TECHNICAL BULLETIN

SQR7080T

No: TB-T0051

Technical Bulletin about Fault of S11+AMT Clutch Position Sensor

2. Install seal washer

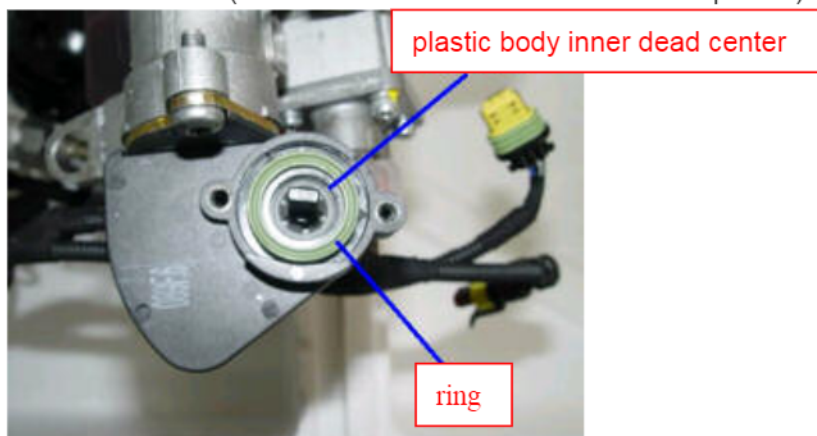
Use a seal (no directional) by hand to cover plastic body inner dead center evenly and press slightly by hand to make it flat (Note: Washer should be in the middle place.)
